Service Bulletin

Bulletin No.: 15-NA-090

Subject: Power Steering Cooling Lines and/or Engine Oil Cooler Line Leak

4331681

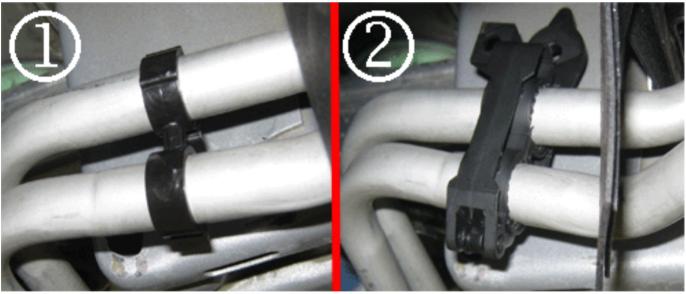
During the installation of the new line, replace the clips holding the lines (1) with the new clips (2) as illustrated above.

The clips should be installed in the approximate location shown above.
